**URGENT – FIELD SAFETY NOTICE**

**GETINGE ED-FLOW AER, ED-FLOW SD AER  
SOFTWARE UPDATE – Field Action 2016-01**

<b>Date:</b>	<b>September XX, 2016</b>
<b>Product Issue:</b>	Because of a software issue, if the compressed air supply of the machine is lost right before or during product supply (DLC detergent, Aperlan Poka-Yoke Agent A/B disinfectant), the machine does not launch or complete the product supply when reprocessing a scope. As a result, no alarm is triggered.
<b>Affected Product:</b>	All Getinge ED-FLOW AER and ED-FLOW SD AER of model number 01280004 – 01280010 – 01280012 – 01280014 - 01280015
<b>Resolution:</b>	Getinge proposes to update the machines to make sure all devices present on the market are working effectively and safely, by updating the software to version 3.1.0
<b>Affected Serial Nos.:</b>	3H070234; 3H070233; 5H100465; 5H100466; 5H100467; 5H100468; 2H100169; 3H100244; 3H020205
<b>Field Correction Notice:</b>	Update the software to version 3.1.0
<b>Pages:</b>	4

*Duration of reprocessing cycle and product intake in an ED-FLOW or ED-FLOW SD AER*

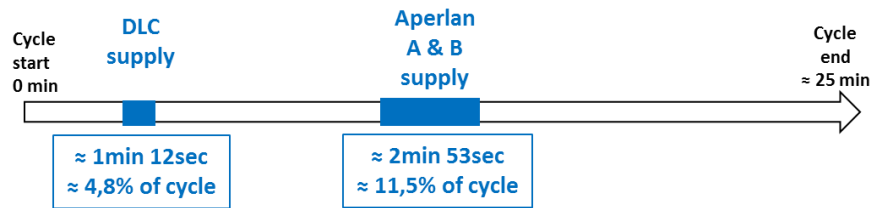
The issue we found can cause a lack of product supply (DLC detergent or Aperlan Poka-Yoke Agent A and Agent B disinfectant) if the compressed air supply of the machine is lost right before or during product supply, and after cycle start, and not re-established before cycle end (periods in blue on timeline).

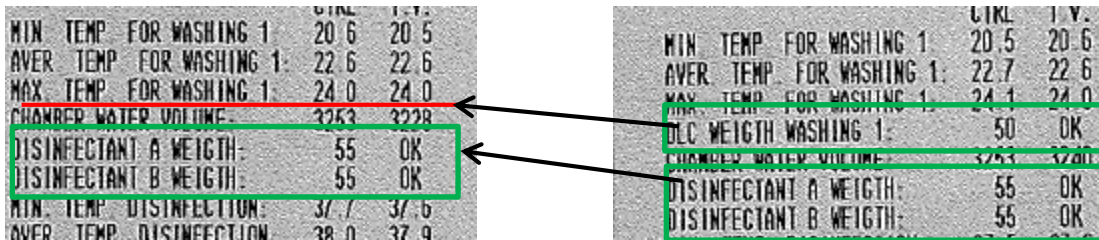
3. In the meantime, this issue can be detected by careful examination of the ticket printed at the end of each reprocessing cycle. **Please make sure to systematically check and record that there are 3 lines printed on the ticket (example below) :**

- DLC weight washing 1 OK
- Disinfectant A weight OK
- Disinfectant B weight OK

If any of these 3 lines is not printed, the reprocessing cycle was not performed properly. **You need to reprocess the endoscope to ensure proper washing and disinfection.**

**Wrong ticket :**  
DLC line is missing

**Correct ticket :**  
all 3 product weight lines are printed
